Work Order ID 54089

DART SERVICE INSTRUCTION

TO AMEND INSTALLATION INSTRUCTIONS IIN-D350-721 REV. A
AND INSTRUCTIONS FOR CONTINUED AIRWORTHINESS ICA-D350-721 REV. 1

A	NEW ISSUE	AJS	09.10.06
REV.	DESCRIPTION	BY	DATE
DESIGN	AJS	DART AEROSPACE LTD HAWKESBURY, ONTARIO, CANADA	
DRAWN	AJS		
CHECKED	<i>[Signature]</i>	DRAWING NO.	REV. A
MFG. APPR.	N/A	DSI 9485	SHEET 1 OF 2
APPROVED	<i>[Signature]</i>	TITLE	SCALE
DE APPR.	<i>[Signature]</i>	ANTI-CHAFING STRIP REPLACEMENT NTS	
DATE	09.10.06	COPYRIGHT © 2009 BY DART AEROSPACE LTD THIS DOCUMENT IS PRIVATE AND CONFIDENTIAL AND IS SUPPLIED ON THE EXPRESS CONDITION THAT IT IS NOT TO BE USED FOR ANY PURPOSE OR COPIED OR COMMUNICATED TO ANY OTHER PERSON WITHOUT WRITTEN PERMISSION FROM DART AEROSPACE LTD.

FIGURE 1 - D2732-030 RUBBER CUSHION INSTALLATION
(4 PLACES PER INSTALLATION)

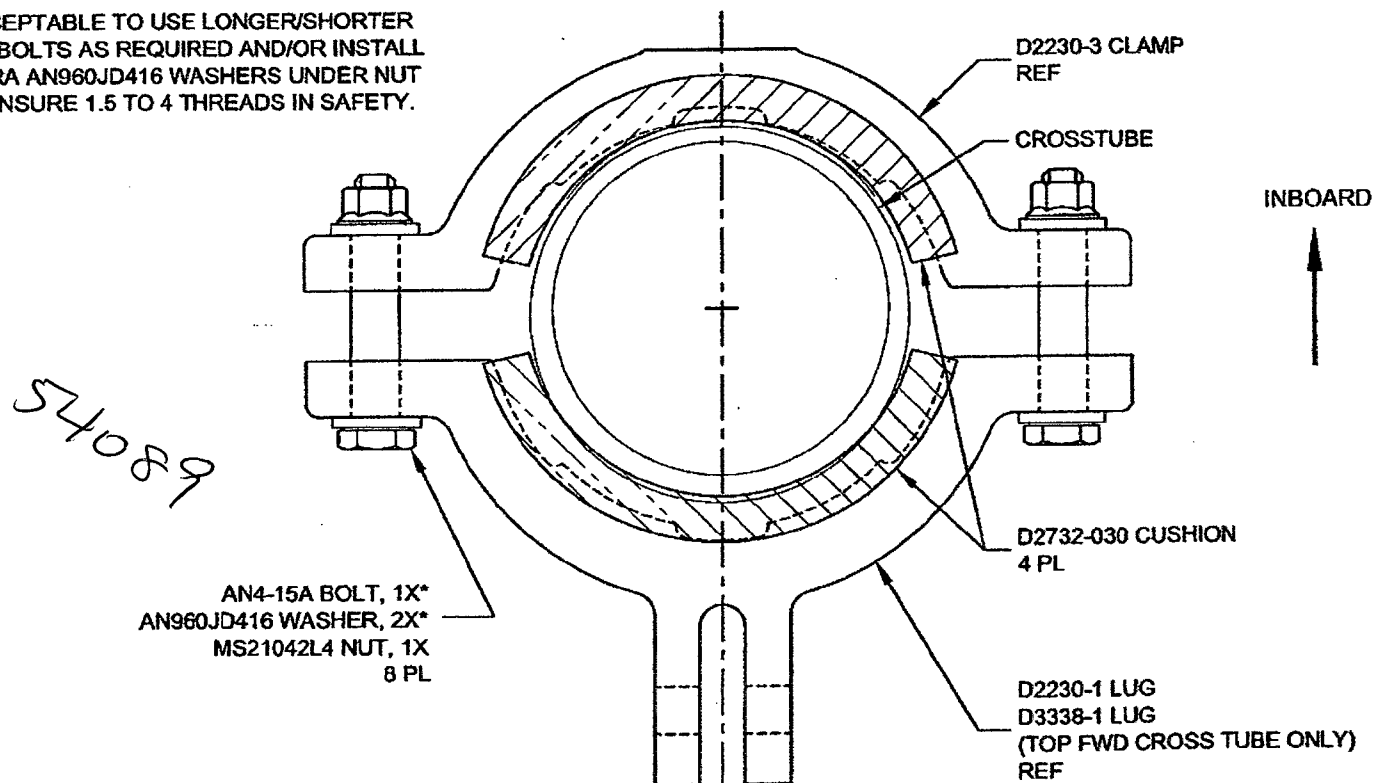
THE PURPOSE OF THIS DSI (DART SERVICE INSTRUCTION) IS TO REPLACE THE EXISTING D2586-400-720 ABRASION STRIPS WITH D2732-030 RUBBER CUSHIONS TO IMPROVE CHAFING PROTECTION BETWEEN THE BASKETS INSTALLATION CLAMPS AND THE AIRCRAFT'S CROSS TUBES.

FOR THE FOLLOWING D350-721-XXX HELI-UTILITY-BASKET INSTALLATIONS, INSTALL THE D2732-030 RUBBER CUSHIONS UNDER THE D2230-1/-3 AND D3338-1 CLAMPS AS SHOWN IN FIGURE 1. THE D2856-400-720 ABRASION STRIPS HAVE BEEN REMOVED FROM THE D350-721-XXX HELI-UTILITY-BASKET KITS.

NOTE: REMOVE THE D2856-400-720 ABRASION STRIP PER SECTION 25.5 OF ICA-D350-721 PRIOR TO INSTALLING THE D2230-1/-3 AND D3338-1 CLAMPS WITH THE D2732-030 RUBBER CUSHIONS.

*ACCEPTABLE TO USE LONGER/SHORTER AN4 BOLTS AS REQUIRED AND/OR INSTALL EXTRA AN960JD416 WASHERS UNDER NUT TO ENSURE 1.5 TO 4 THREADS IN SAFETY.
